dtefh 1D: D412-664-203 Accept *N900040100* Setup Start **Revision ID:** Item Name: Crosstube Aft **Start Date:** 07/06/2012 Start Qty: 1.00 **Cust Item ID: Required Date:** 21/06/2012 Req'd Qty: 1.00 **Customer:** Reference: Run Process Plan: ML5 Date: 12/06/07 Tooling: **Approvals:** Date: QC: * SPC (Y/N): Date: Operation _____ Sequence ID/ Set Up/ Tool # Plan Reject Accept Reject Insp. Work Center ID Description Run Hours Code Qty Qty Number Stamp Draw Nbr Revision Nbr E/DEO D412-664-243 100 DOCUMENT CONTROL *100* DC Document Control Photocopy bluefile and create labels as per PPP D412-664-203 CAGO 110 Packaging Packaging Memo Packaging

DART AEROSPACE LTD	Work Order:	45369
Description: Crosstube High Aft (412)	Part Number:	D412-664-203
Inspection Dwg: D412-664-243 Rev: E		Page 1 of 1

DESIGN	PH	DART AEROSPA	CE LTD			
DRAWN	RF	HAWKESBURY, ONTARIO,	HAWKESBURY, ONTARIO, CANADA			
CHECKED	40	DRAWING NO.	REV. E			
MFG. APPR.	77	D412-664-243	SHEET 1 OF 4			
APPROVED	140	TITLE	SCALE			
DE APPR.	-#	CROSSTUBE ASSEMBLY (412	HIAFT) NTS			
DATE 09.0	9.30	COPYRIGHT © 2001 BY DART AEROSPACE LTD THIS DOCUMENTS PRIVATE AND CONFIDENTIAL AND IS SUPPLIED ON THE EXPRESS CONSTRONT THAT IT IS NOT TO

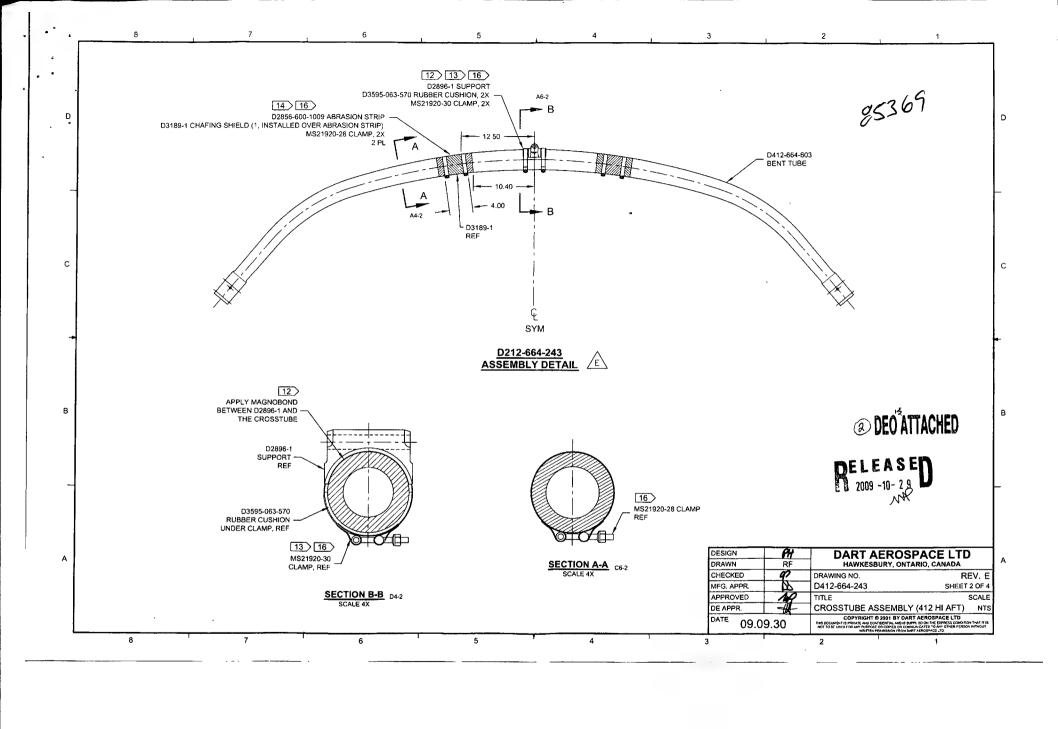
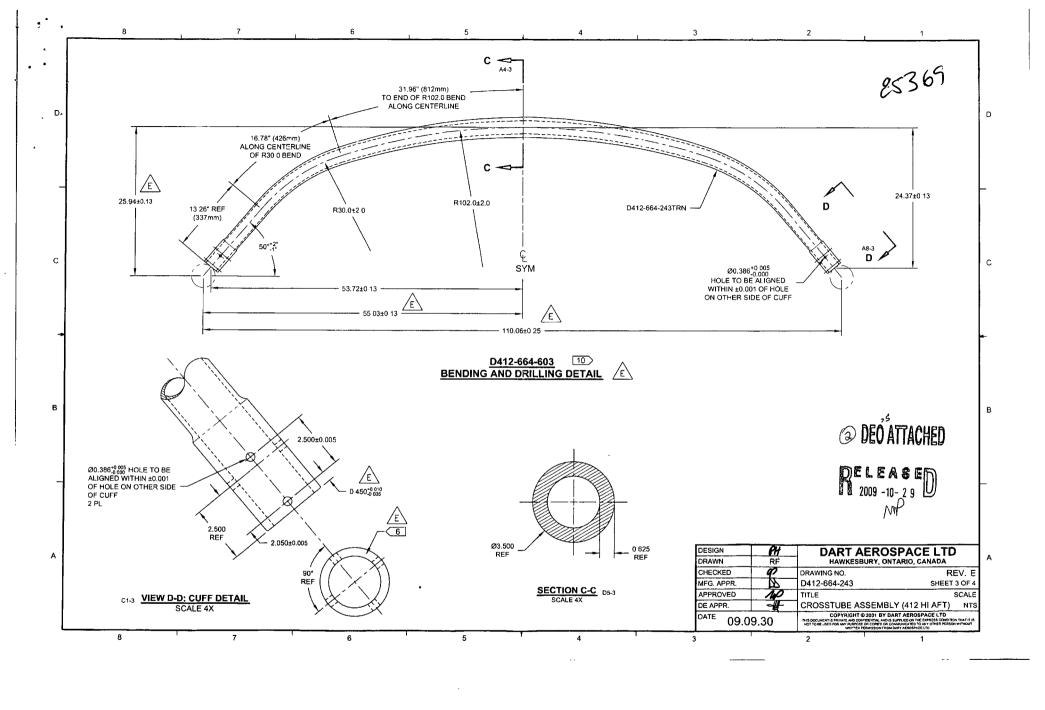
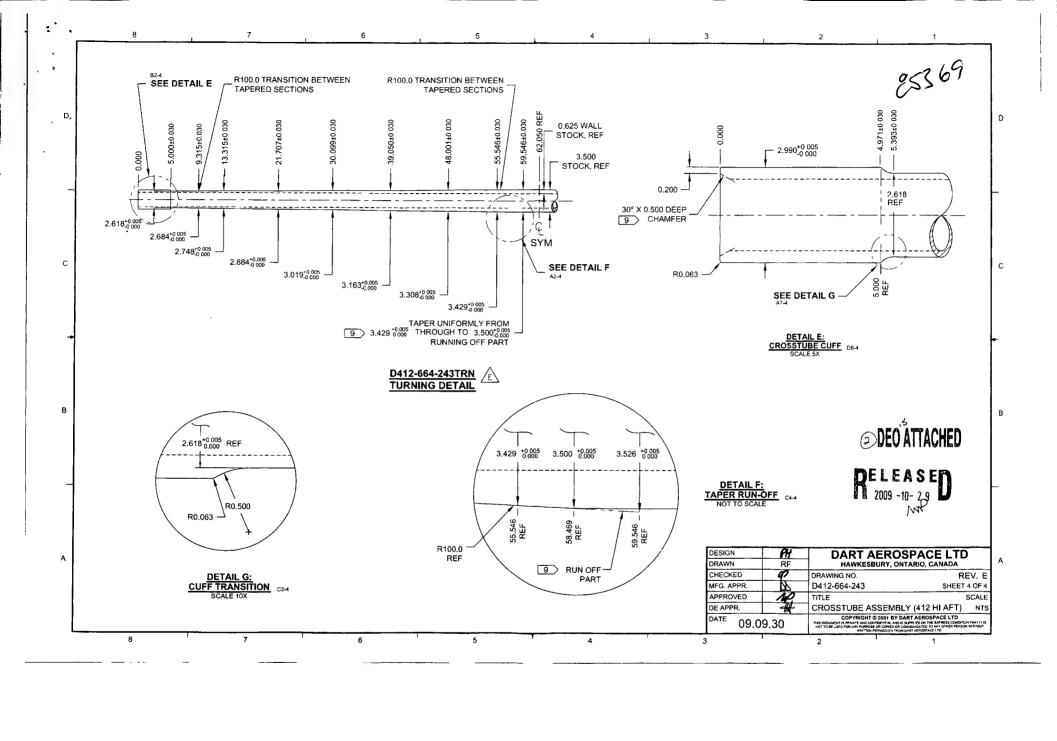
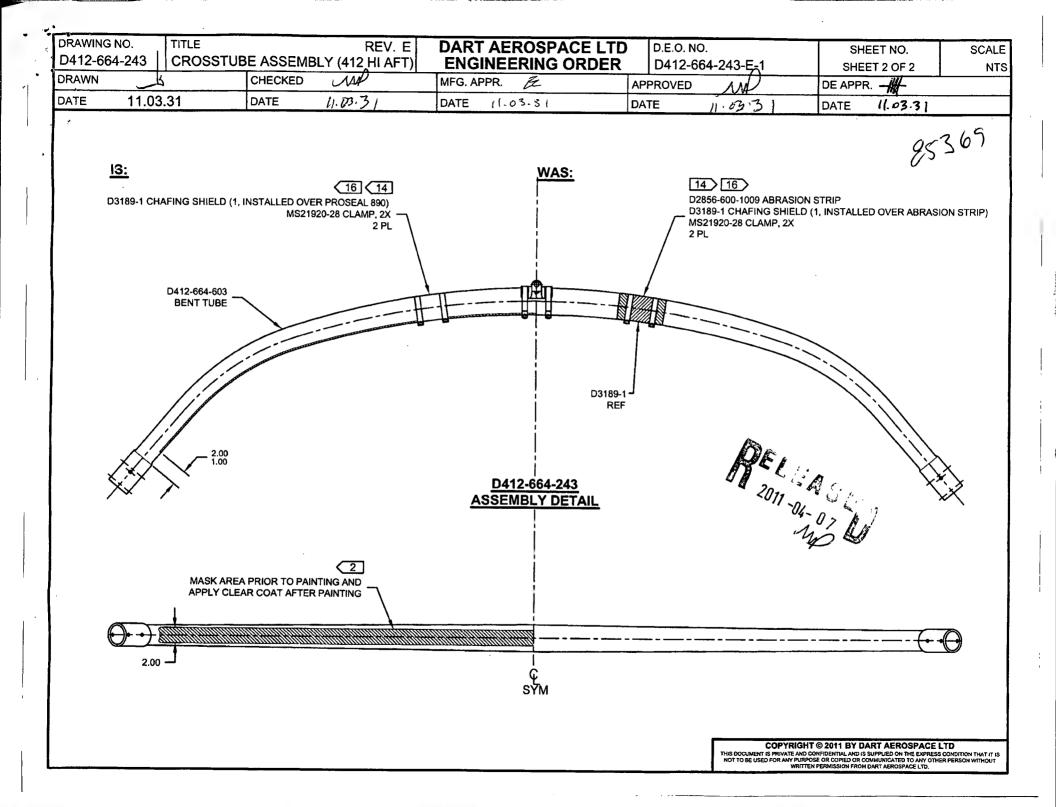
NCR: 17	1596	We	ORK OR	DER NON-CONFORMANCE	E (NCR)			- /
DATE	0755	Description of NC		Corrective Action Section B		Verification	Approval	Approval
DATE	STEP	Section A	Initial Chief Eng	Action Description Chief Eng	Sign & Date	Section C	Chief Eng	QC Inspecto
17/6/13	120	Benting 15 over tyloranece after bending	12/6/13	Acceptable per affached SR	4/4	16. 210312	12/6/13 PSJUR	76 16 10746
		**,						
	- <u>1</u>	**

Comments						
SiDO AZ 6.2% cru	hing Wag Pases-					
5,20 Bz 7,476 CM	why QB PASES					
	A cceptable 4 12/6/13					
QC15 Inspection	8					
Date	12/46/12
